Part Change Notification:

Change to MLS Flatpack series electrolyte system

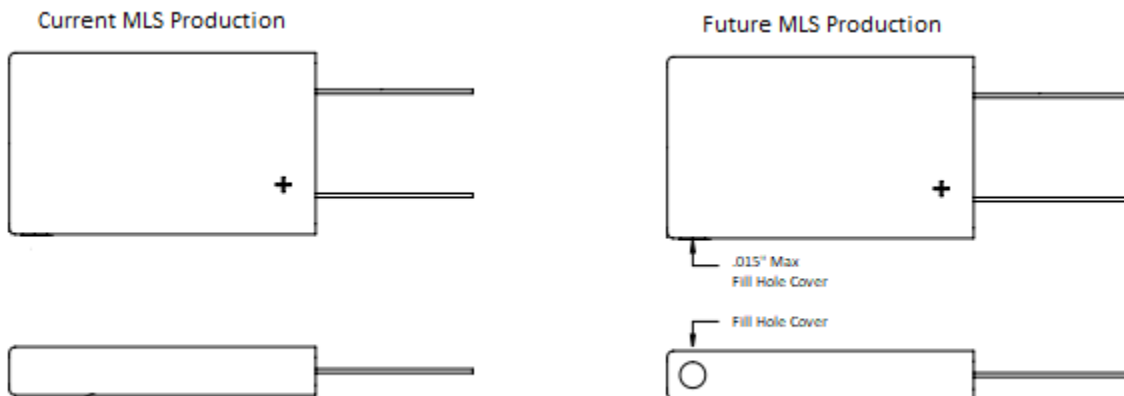
We have conducted exhaustive tests with the new electrolyte system and we can assure our customers that there will be no change to the form, fit, or function of the capacitors. The only discernable change will be to the fill-hole location. As an example, the following drawing shows the laser welded fill-hole repositioned to the narrow side and toward the bottom of the capacitor.

Starting July 7, 2018, we will begin manufacturing MLS part numbers with the new electrolyte and change to fill-hole location. There will be no change to the part number. The conversion of the entire series to the new electrolyte is expected to take 6 months.
